Planning and Land Use Department Planning Commission Staff Report

<p>Case No: 2025-11526 (Final Subdivision Plat)</p> <p>Hearing Date: December 4, 2025</p> <p>Applicant: Homewise, Inc.</p> <p>Agent: JenkinsGavin, Inc.</p> <p>Request: Final Subdivision Plat</p> <p>Location:</p> <p>Case Mgr.: Rebekah Clouser</p> <p>Zoning: PRC (Planned Residential Community)</p> <p>Overlay: Suburban Archaeological Review District</p> <p>Pre-application Mtg.: March 12, 2025</p> <p>ENN Mtg.: May 29, 2025</p>	
<p>Proposal: Final Plat approval for 16 development tracts and 6 open space tracts, innovative street designs.</p>

Case #2025-11526. Tierra Contenta Final Subdivision Plat. JenkinsGavin, Inc., Agent for Homewise, Inc., owner and applicant (“Applicant”), requests review and approval of a Final Subdivision Plat for 16 development tracts and 6 open space tracts for a total of 22 tracts and Innovative Street Design. The subject lots are 216.5 acres and are located at 6120, 6130, 6150, and 6135 Paseo del Sol. The lots are zoned Planned Residential Community District (PRC) and lie within the Suburban Archaeological Review District. (Rebekah Clouser, Case Manager, reclouser@santafenm.gov).

Figure 1: Approved Water Plan

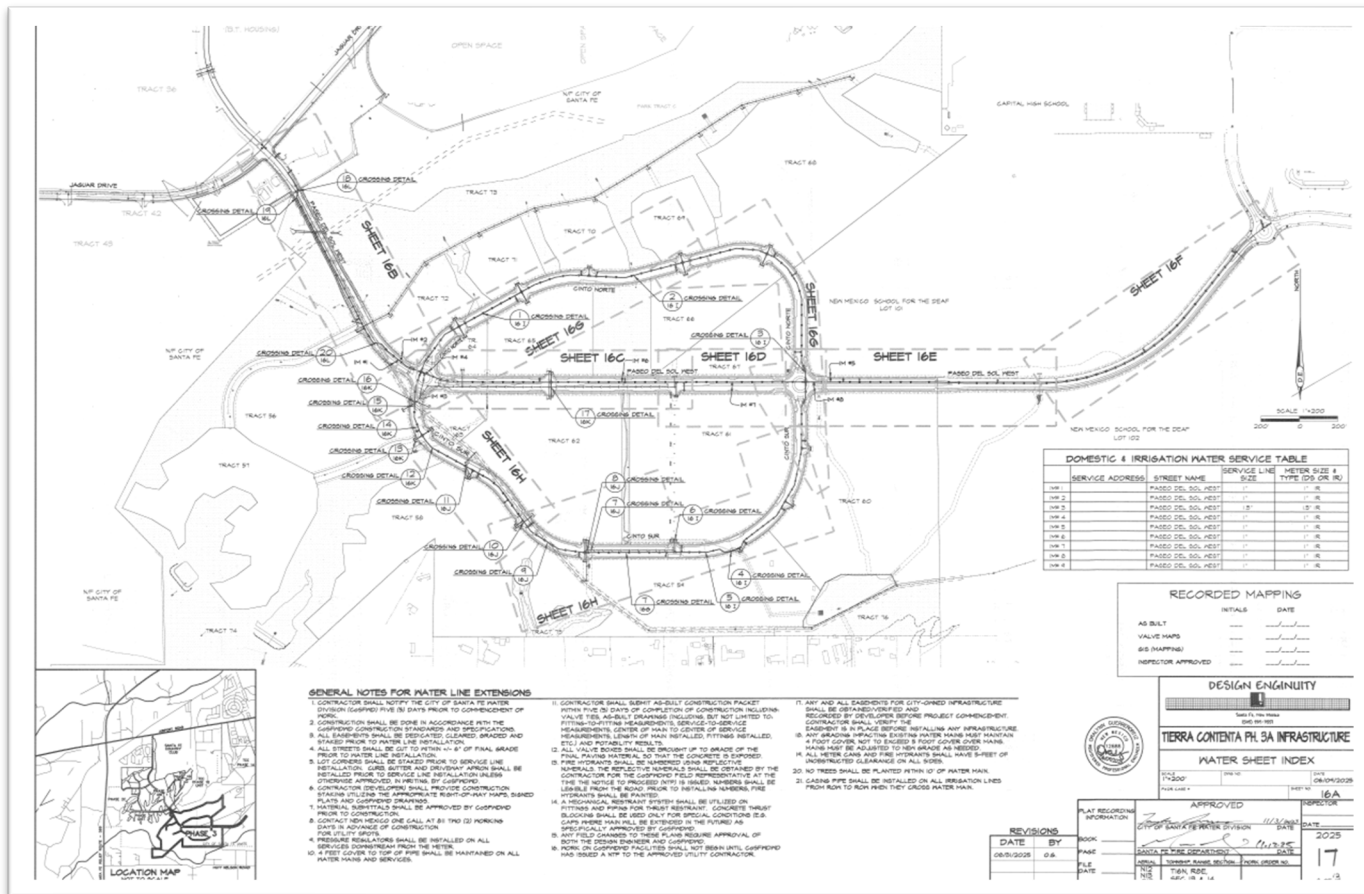
The Applicant submitted a water utility plan within the subdivision plan set. The Applicant has complied with water engineering conditions and received an approved water plan, see *Figure 1: Approved Water Plan*. All sheets for the water plan can be found in Attachment B7: Water Plan
